49 CFR Part 571

[Docket No. NHTSA-2004-17917]

Tire Safety Information

ACTION: Final rule; response to petitions for reconsideration; technical amendment.

Figure 1

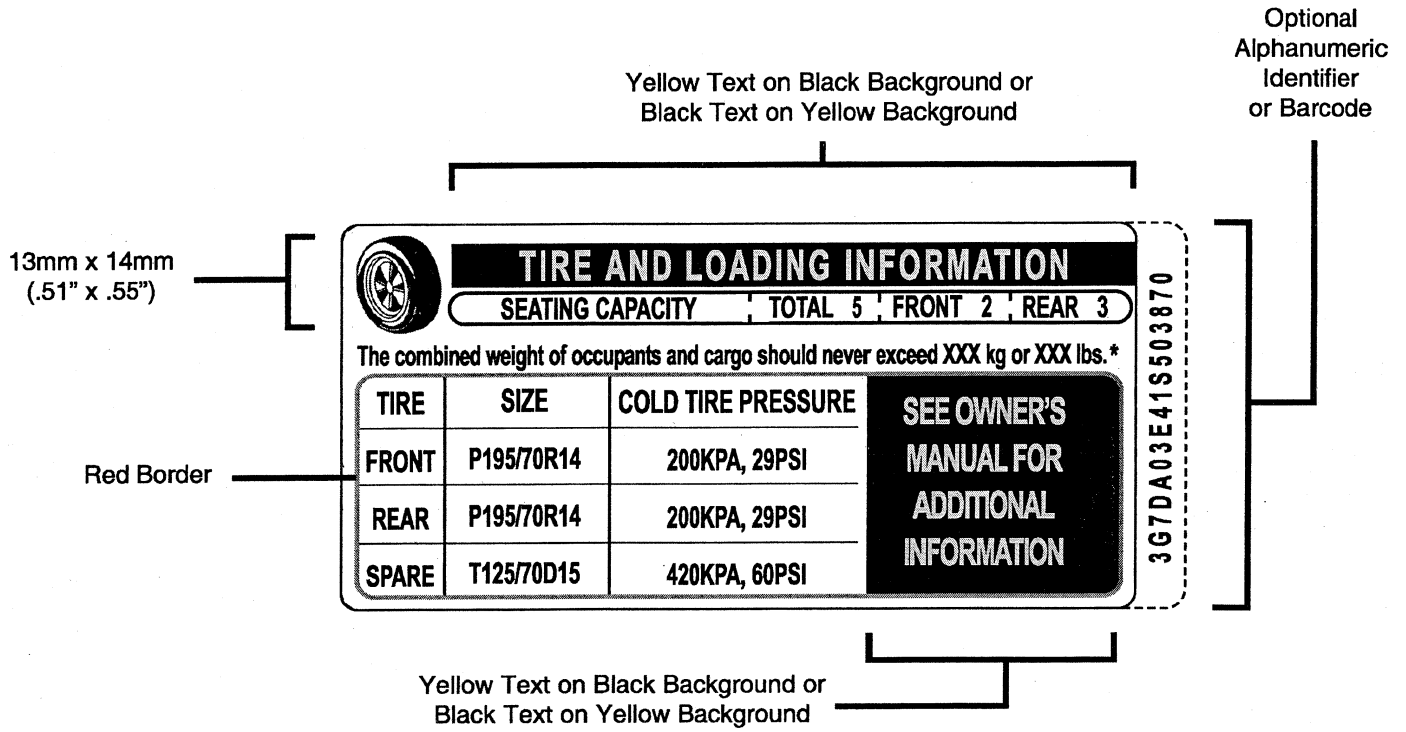
■ 2. Section 571.110 is amended by revising S4.2.2; S4.3(c), (d), (h) and (i); the example in the last paragraph of S4.3.3; S4.4.2 introductory text; and Figures 1 and 2 at the end of Section 571.110, to read as follows:

(h) At the manufacturer’s option, identifying information provided in any alphanumeric and or barcode form, located vertically, along the right edge or the left edge of the placard or the label, or horizontally, along the bottom edge of the placard or the label; and

(i) At the manufacturer’s option, the load range identification symbol, load index, and speed rating, located immediately to the right of the tire size designation listed in accordance with S4.3(d) above.
